DATE: April 6, 2016

AGENDA ITEM # 4

TO: Design Review Commission
FROM: Zachary Dahl, Planning Services Manager
SUBJECT: 14-SC-48 and 14-H-03 – 980 Covington Road

Figure 3. Chapman Design Associates - Proposed Rear Addition (section of sheet)

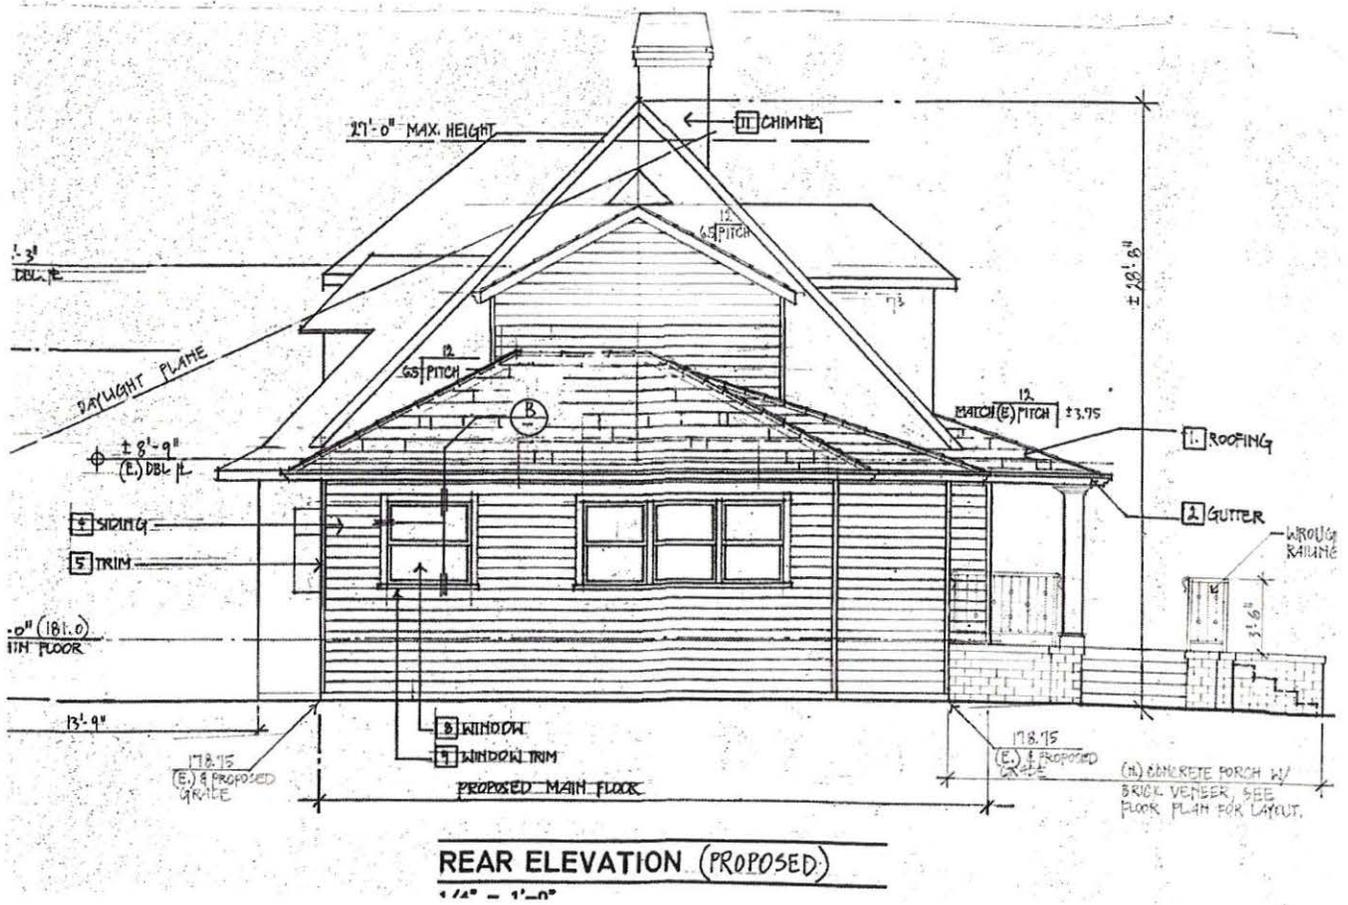
The addition is shown on the Chapman Design Associates sheet 9-A to be differentiated by the use of siding that is a different style horizontal board one that appears to be wider than the original siding. This difference in the size of the boards will show the distinction between the original building and the addition.

Showing: The proposed residential design does not diminish the massing or character defining elements of the historic house. The siding is differentiated from the historic house by using a wider board. The proposed terrace is also shown on the right with brick veneer. The railing style has been changed Sheer A-9-A
